Town Planning Committee Tuesday, 1 November 2022 at 6:30 PM

12.1 14 GEORGE STREET - ALTERATIONS AND ADDITIONS

The purpose of this report is for Council to consider a development application for proposed alterations and additions at 14 (Lot 2) George Street, East Fremantle.

Proposed Ground Floor Plan

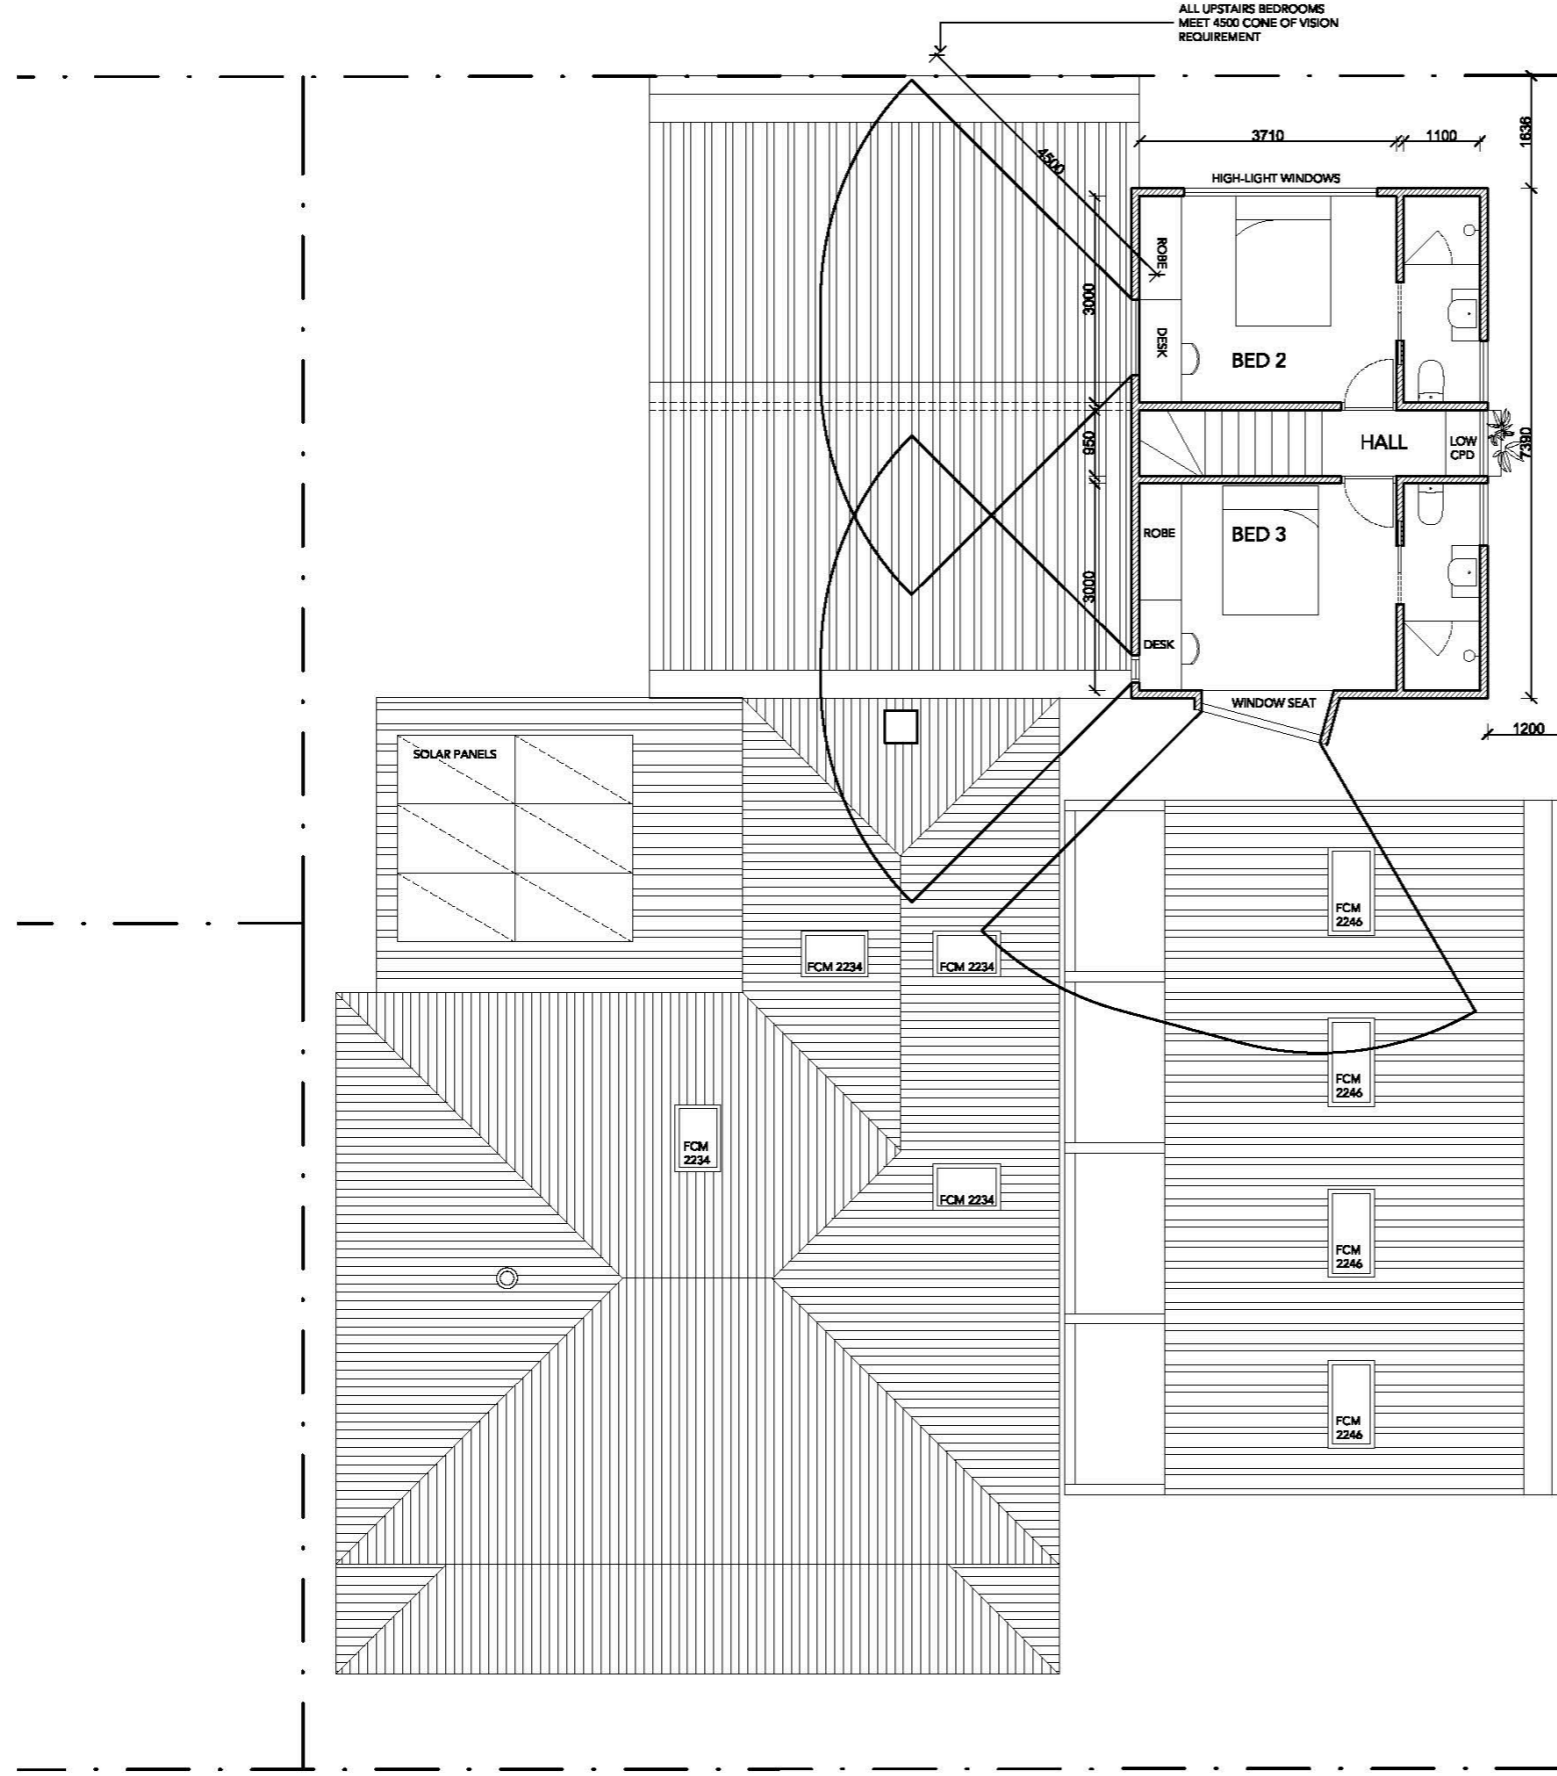
In accordance with Local Planning Scheme No 3 clause 5.8.1 lot boundary setbacks are required to be 0m within the mixed-use zone for those properties that are adjacent to other mixed-use sites. In this case the lot boundary setback is 1.202m for this section of the dwelling. This property is intended to be residential and therefore the setback ensures that there is space between neighbouring properties and ensures that other services can be designed into the building, including the requirement for adequate space for rubbish bins, adequate space for air conditioning units, and a small garden. For this reason, the increased lot boundary setback can be supported.

In accordance with Local Planning Scheme No 3 clause 5.8.1 lot boundary setbacks are required to be built up to the boundary (0m setback) within the mixed-use zone. In this case the lot boundary setback is 1.2m for this section of the dwelling which is 7.39m long and 6.08m high on the eastern side of the property. This property is intended to be residential and therefore the setback ensures that there is space between neighbouring properties that increases visual privacy and reduces amenity impacts. For this reason, the increased lot boundary setback can be supported.

In accordance with Local Planning Scheme No 3 clause 5.8.1 buildings are required to be located on the front boundary. To lessen the impact of the additions that are proposed to the existing dwelling the garage has been setback 3.963m from the front boundary and approximately 2.5m behind the existing building line which ensures that the garage does not become the dominant feature of the proposed dwelling. By doing this the impact of the additions is lessened and the character and features of the heritage property are not denigrated.

Proposed Elevations

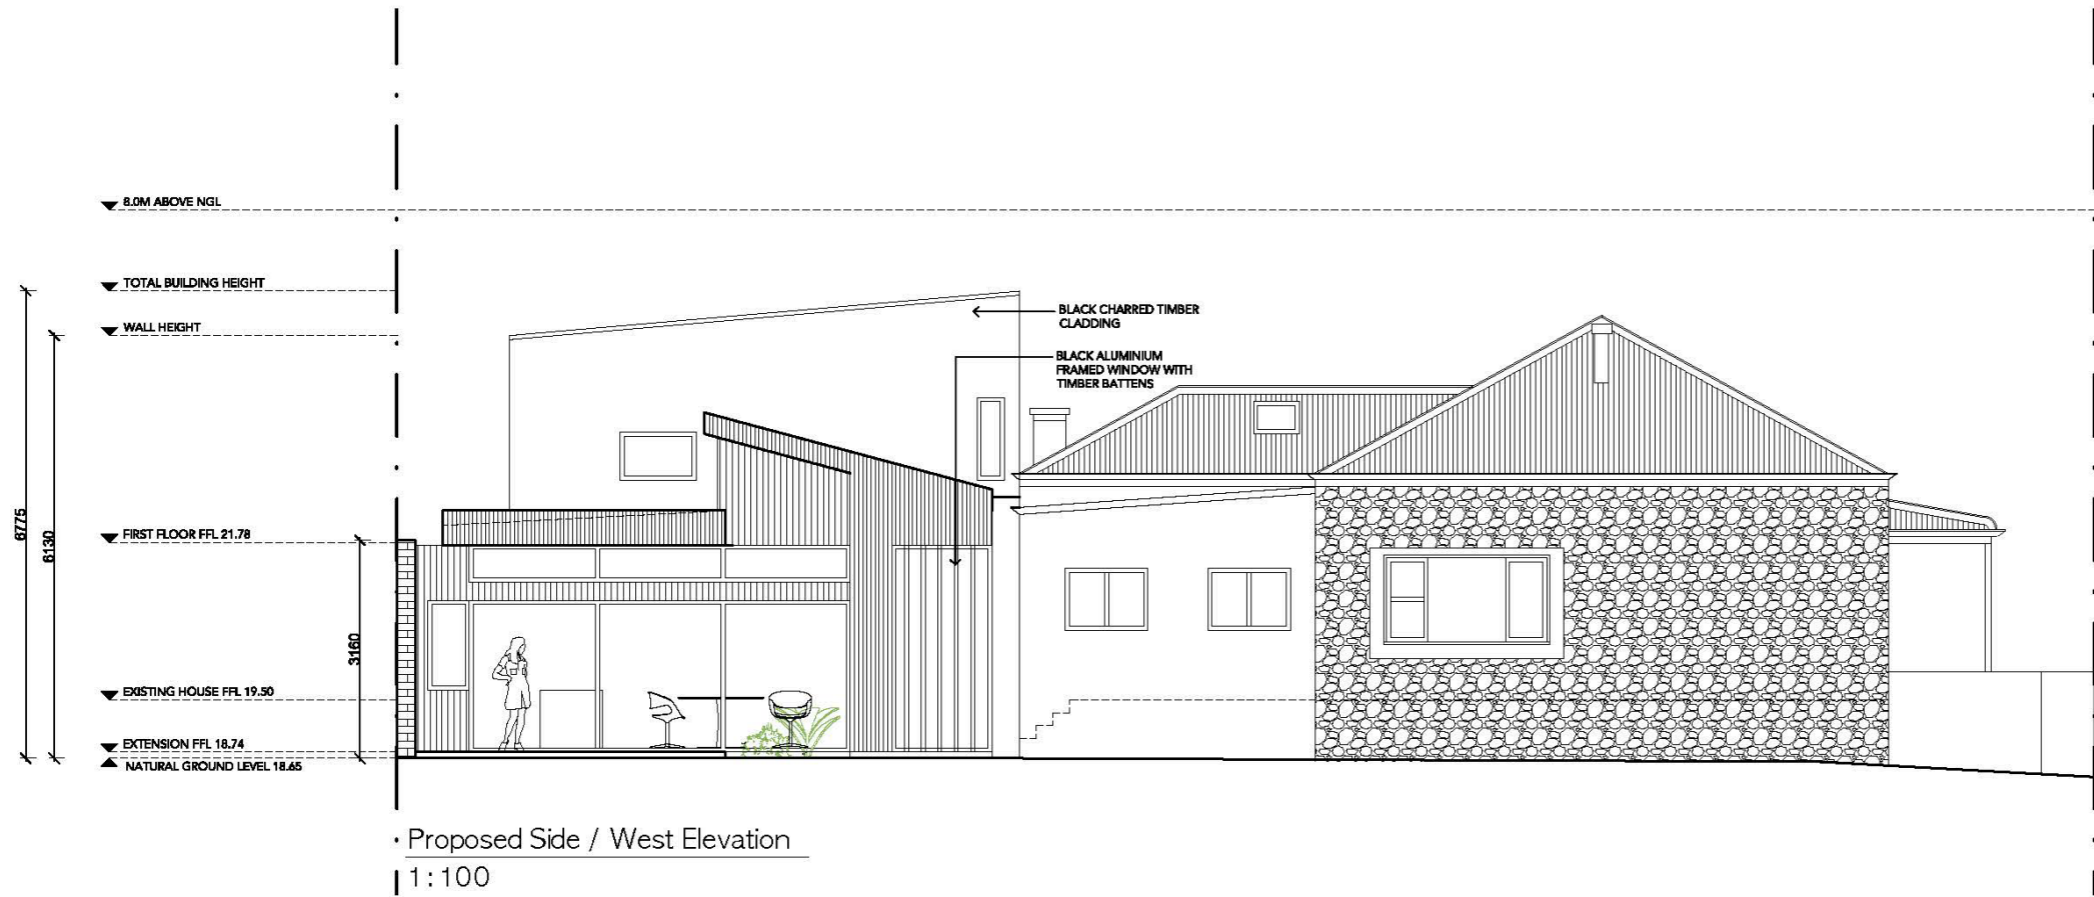
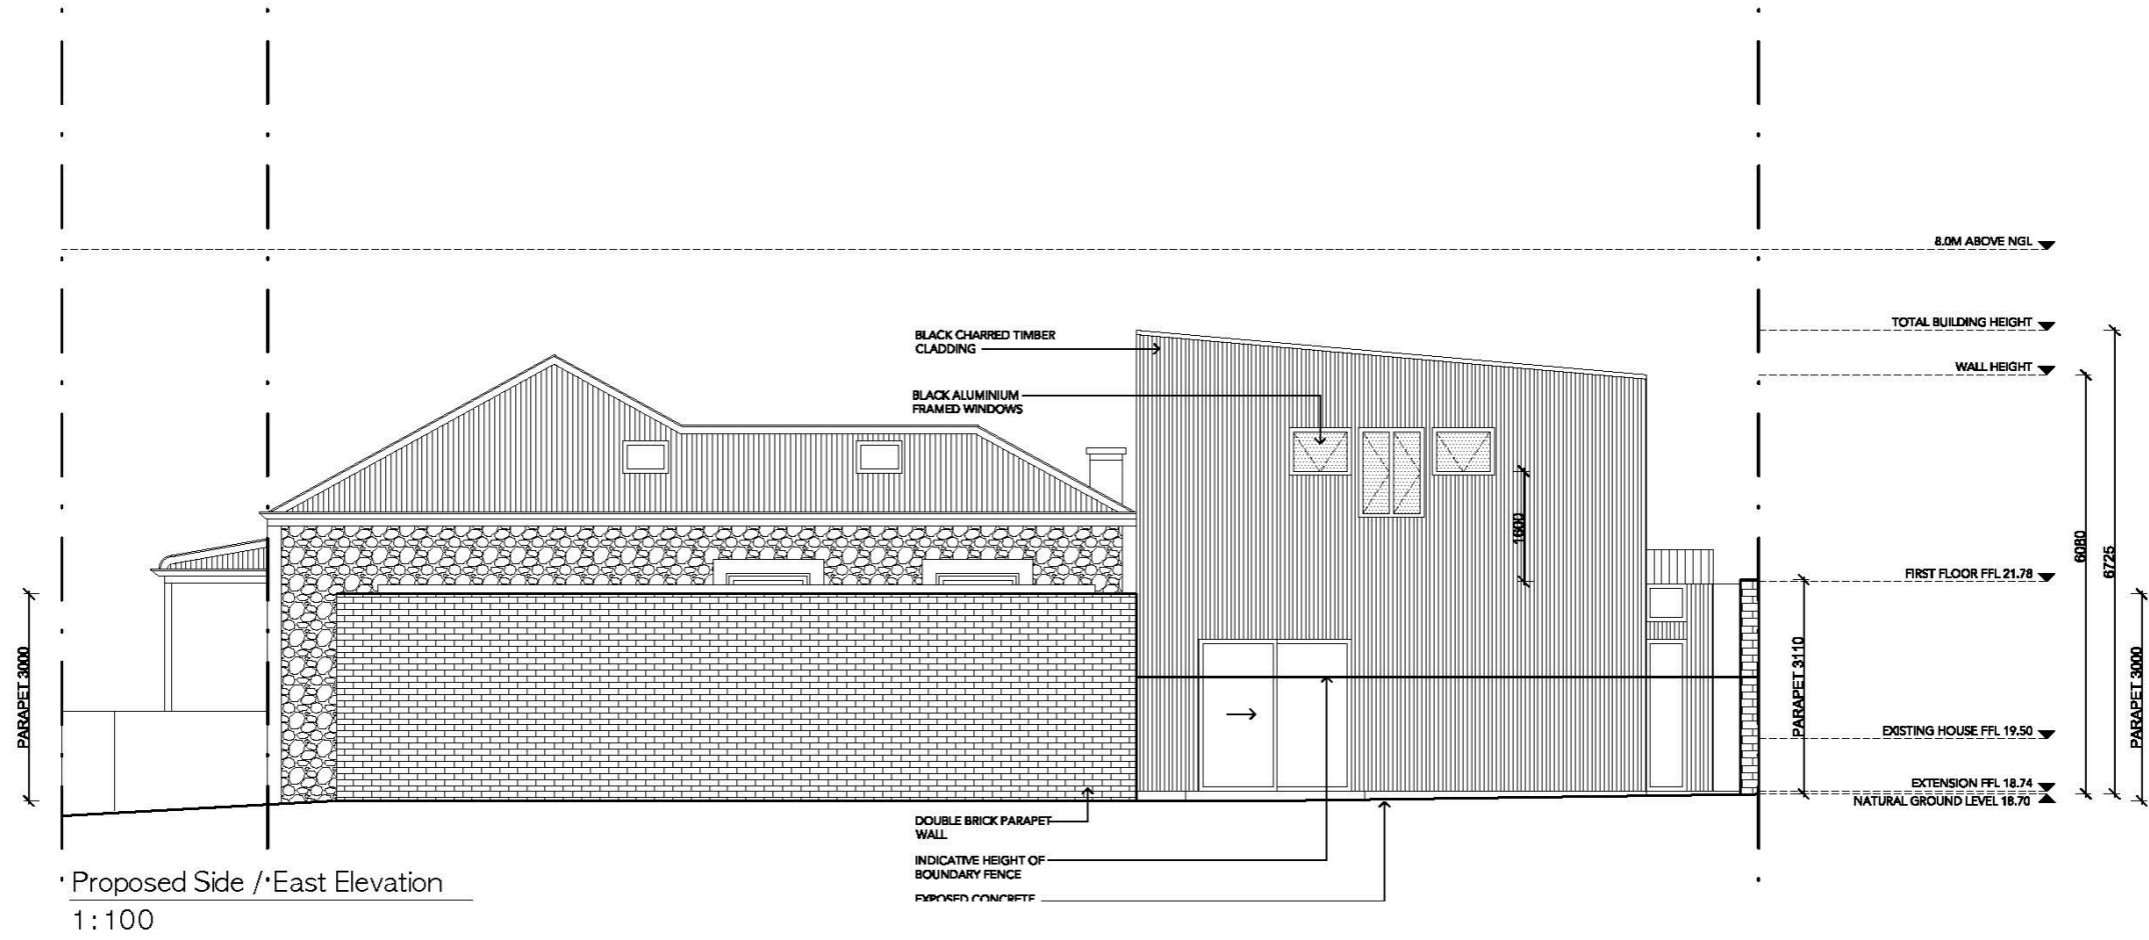
Local Planning Scheme No 3 clause 5.8.2 (c) requires that the maximum wall height in a mixed-use zone is no more than 5.5m high. In this case the maximum wall height is 6.08m (for the wall of the double storey addition at the rear of the site). This is for a limited part of the dwelling and only marginally higher than the maximum wall height that is permitted for structures in the George Street mixed use zone. It is noted that the building is lower than the neighbouring property to the west, and the Harbour Heights development directly over the road from this proposed development.
